PRELIMINARY REPORT OF SURVEY

Jack-up Rig THULE POWER

Fode Ltd

Dates: 5 - 11 April 2009

5.11 **Derrick**

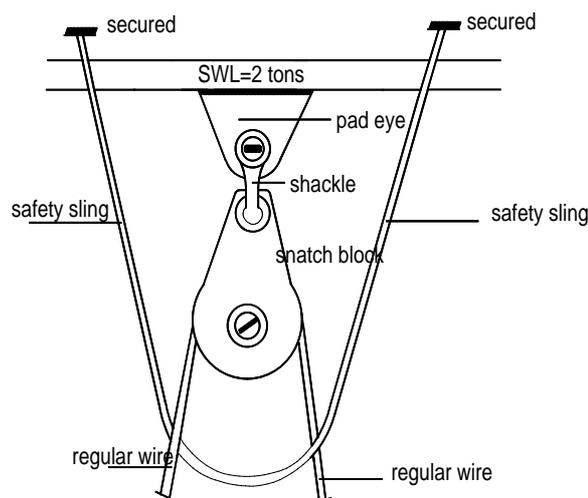
The derrick was climbed in order to carry out a visual inspection, it was obvious that that the derrick had not been involved in any drilling operation as it was very clean. A number of safety concerns were addressed at the derrick inspection which should be rectified or implemented before the rig starts the drilling operation.

As there were no documentation available we would recommend that the certificate is reviewed as well as it should be verified if the derrick has been load tested after completion. It was noticed that the derrick structure at the PS aft derrick leg had delaminated on the other surface over approximately five meters, it should be verified that this is mentioned and accepted in the final documentation for the derrick.

The derrick name plate required by API RP 54 Section 9.2.2 & API Spec 4F Section 4.2 was not sighted on the derrick structure. Although it is a Norsok requirement we would still recommend the gates on the resting platforms to be of the self closing type which they are not. The derrick ladders felt safe to climb despite the fact that a few rungs were bended and there were no climbing assist line installed. Although provisions were made there was no derrick man escape system installed, it must be ensured that a derrick man escape system is installed prior to the drilling operation commences. The house keeping on the monkeyboard level were very poor although the final installation were not complete as scaffolding was erected there was various pieces of equipment laying around on the grating, a piece of electric cable were sighted in one of the derrick members it strongly recommended that a tidy up session is held when the installation work is completed in order to prevent any dropped object incidents. There rig was equipped with two small 1000 LBS Ingersoll Rand remote controlled air winches of which one was laying loose on the monkeyboard level, the other was installed however there was no safety guard installed on the drum. Its recommended to have guards installed as well as the spare tugger should either be installed or removed from the monkeyboard. A grease manifold were sighted at the crown level, grease lines were noted to be routed to the crown block, deadline and fast line sheaves however the piping routed to the sheaves beneath the crown block were not connected up to the sheaves. Two by two tugger deflector sheaves installed on beams in the derrick had no remote grease tubes installed which is recommended to ensure that they will be greased on regular intervals.

It was noticed that there were no safety slings installed on any of the tugger sheaves installed beneath the crown level as well as the shackles, sheaves etc had not been colour coded as part of regular lifting gear inspections. The pad eyes were not marked with their respective SWL, although this is a Norsok requirement we still recommend SWL to be painted on all pad eyes to prevent mistakes and incidents in the future drilling operation.

| 5.11.1.1 | Critical | Install a drum guard on the monkeyboard tugger. |
| 5.11.1.2 | Critical | Tidy up the entire derrick prior to operation. |
| 5.11.1.3 | Critical | Fit the derrick man escape system. |
| 5.11.1.4 | Critical | Install safety wires on tuggers beneath the crown block. |
| 5.11.1.5 | Major | Verify if a derrick load test has been carried out after completion. |
| 5.11.1.6 | Major | Install derrick nameplate as per API RP 54 Section 9.2.2 & API Spec 4F Section 4.2. |
